# ISSUED FOR DR-3 RESPONSE

(DP2025-02420)

## "PARKLINE" PHASE 1 - MULTI-FAMILY BLDG

TBD RICHMOND RISE S.W.

drawing **Main Floor Level Site Plan - Landscape**

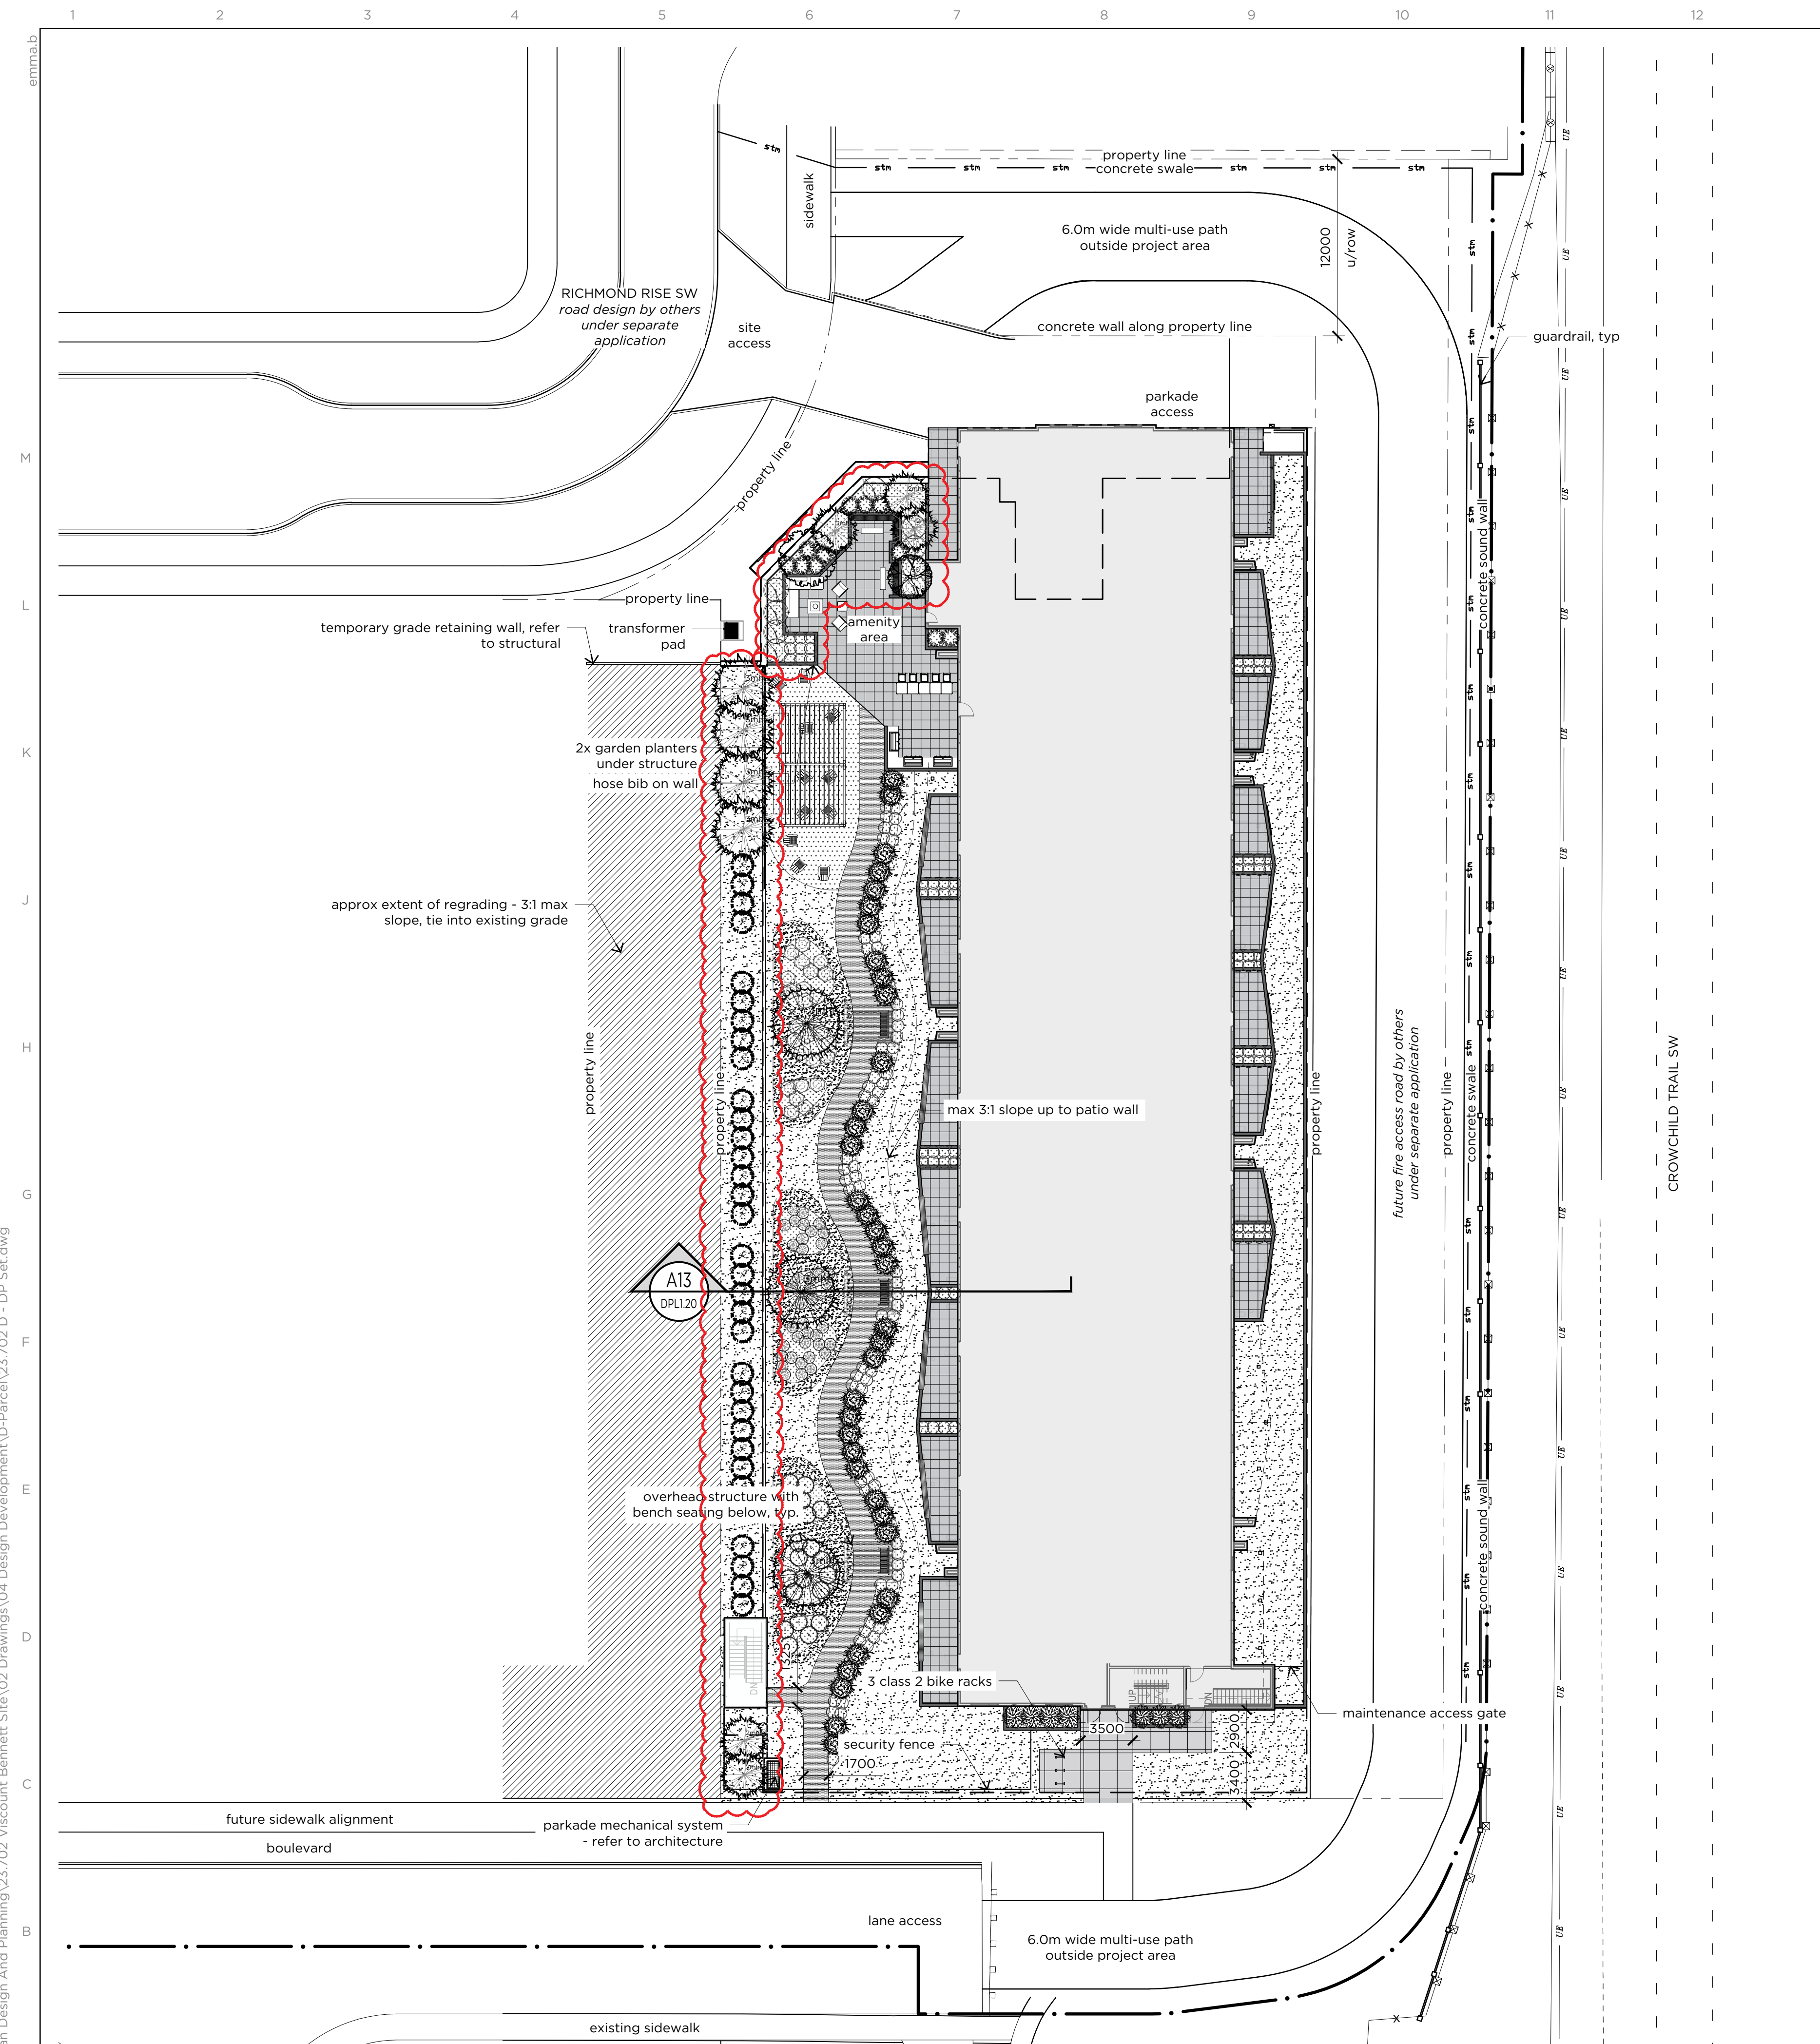
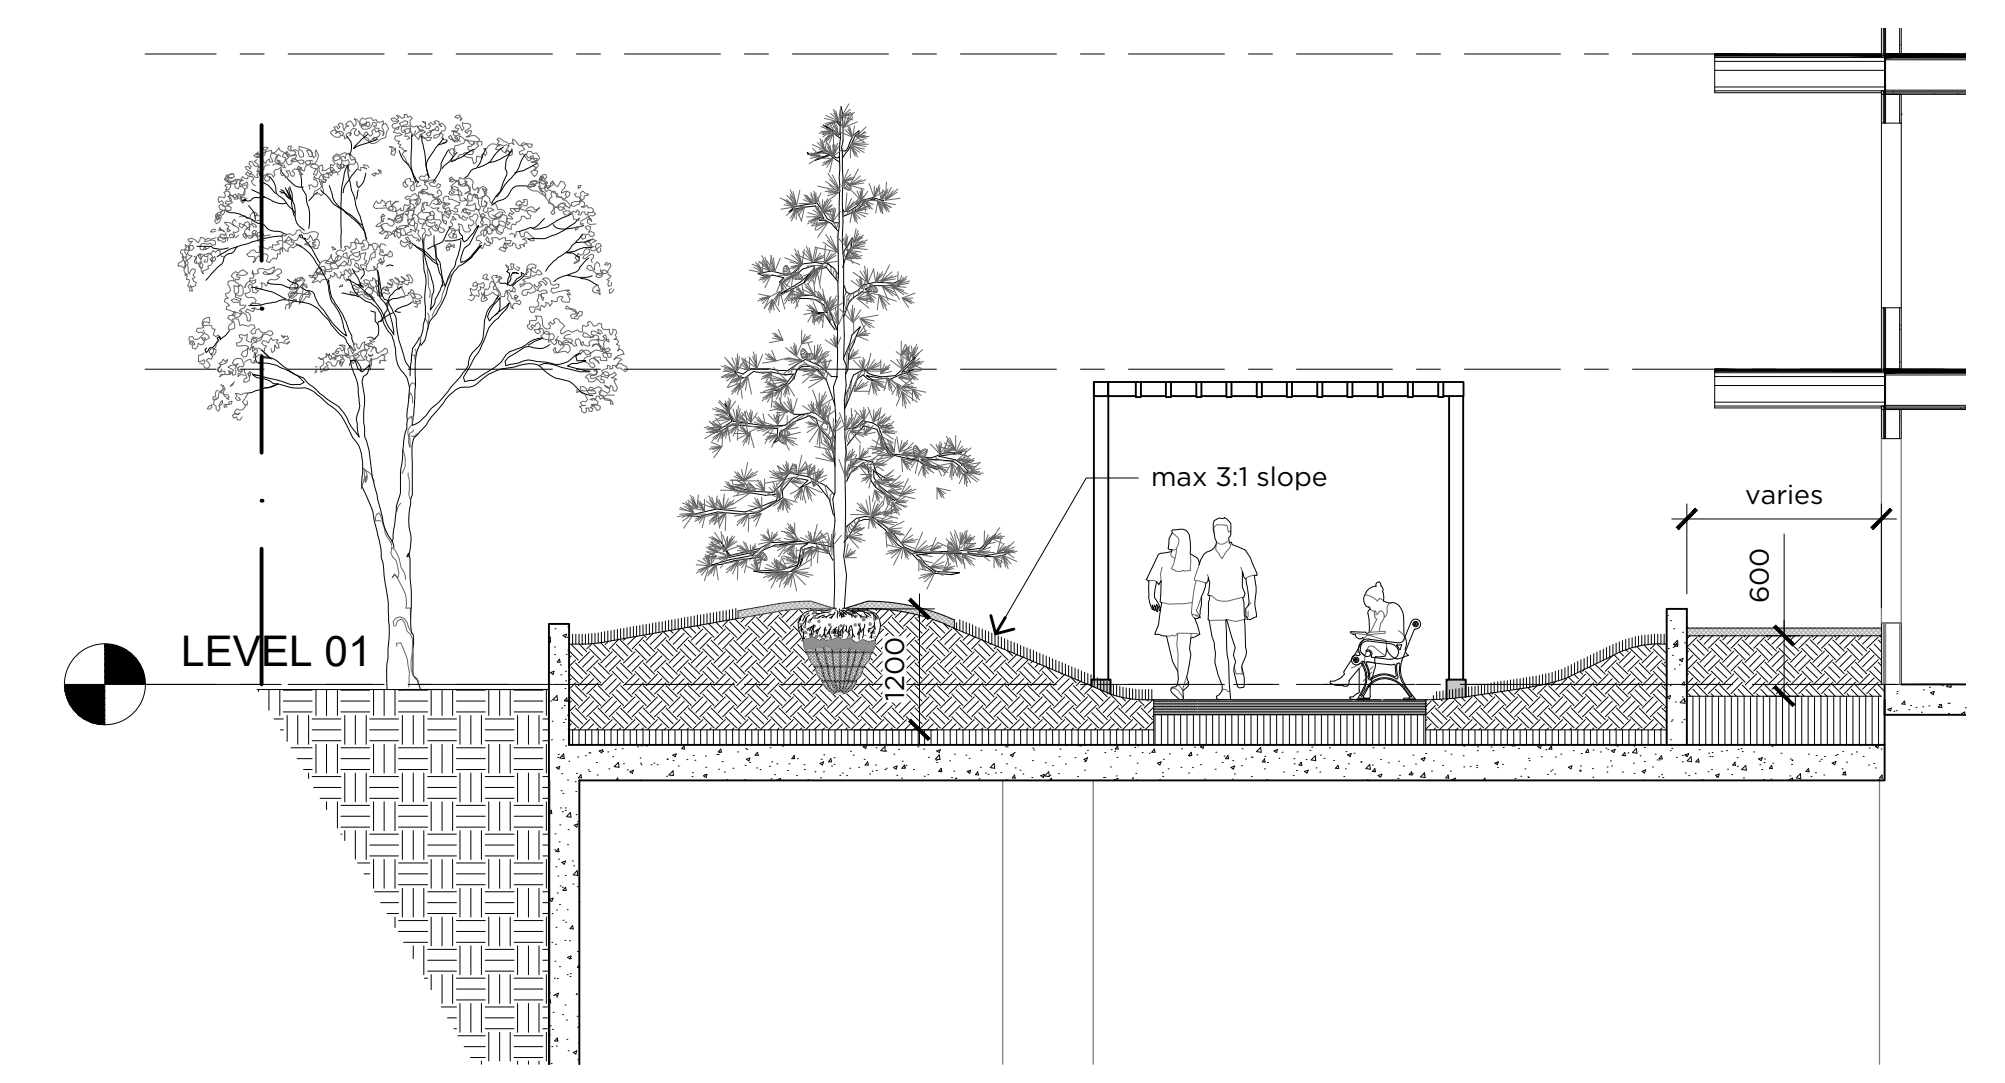
- 1) plant quantities have been updated to include planting on the parkade level (at front entrance), which was previously omitted.
- 2) tree caliper sizing has been adjusted on plan to match quantities provided in proposed plant list
